Sheringham Shoal and Dudgeon Offshore Wind Farm Extension Projects

The Applicant's Comments on Responses to the Examining Authority's Third Written Questions

Document Reference: 20.2

Figure 1: Overview of area

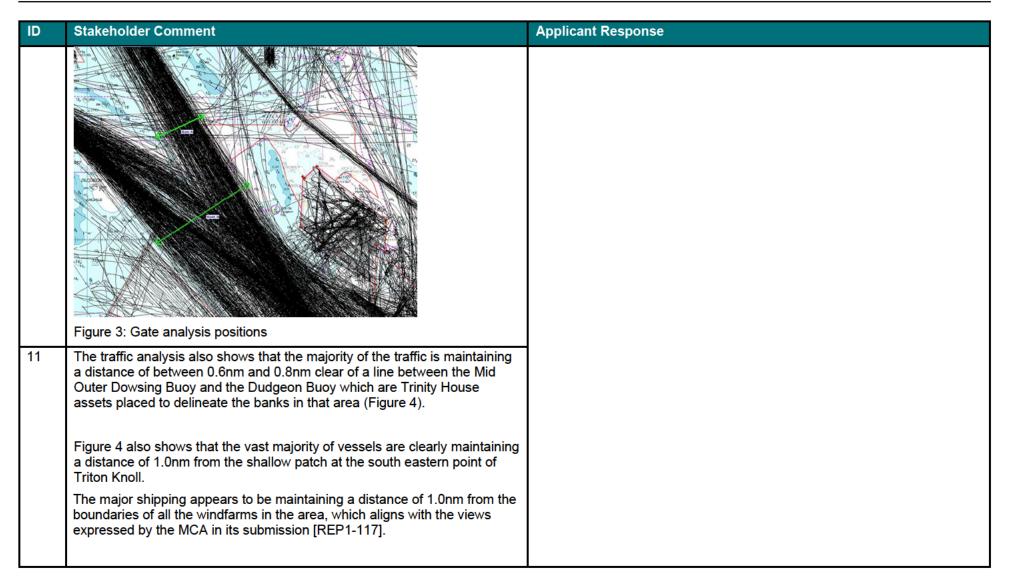
ID	Stakeholder Comment	Applicant Response
	Rescue (SAR) capability is maintained. As such Trinity House respect the MCA recommendations and advice in relation to ship routing.	
	When assessing the proposed DEP north boundary, 28 days AIS data supplied by the MCA and processed for Trinity House by Anatec has been used. This dataset related to the period mid- July to mid-August 2022. The dataset for a wider area has been viewed to try and assess the routeing of the vessels and possible changes if the windfarm were to be consented with the current red line boundary / order limits.	
9	As stated at the first issue specific hearing and as set out in Trinity House's submissions at Deadline 1 [REP1-163], Trinity House do consider that the compression of marine traffic would increase the risk of collision, and from reading the submissions listed in the ExA's question and from the submissions that point is agreed by all parties, albeit to differing levels.

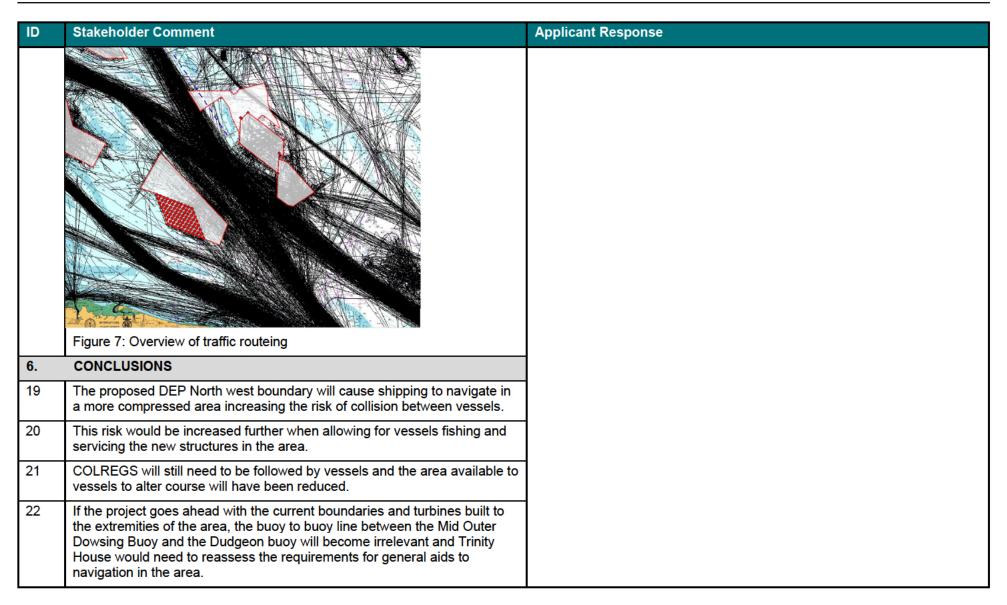
ID	Stakeholder Comment	Applicant Response
	Figure 6: Proposed DEP Boundary and buoy to buoy line with traffic	
15	As can be seen from Figure 6 this does present an enhanced risk of collision by compressing the traffic into a channel which could be approximately only 2 miles wide when passing the end of the Triton Knoll. Vessels are currently allowing a safe passing distance of 1nm from the bank so it could be argued the effective sea space is now only about 1nm. If consideration is then given to fishing activity in the area, and to additional vessels servicing the windfarm, then the enhanced risk of collision could become significant.	
16	In the NRA [APP-198] Sec 20.1 Safety Zones Para 402 the Applicant lays down its expectation for safety zones during all phases of the project and these include "500m around any structure where construction is ongoing, as denoted by the presence of a construction vessel" and "500m around
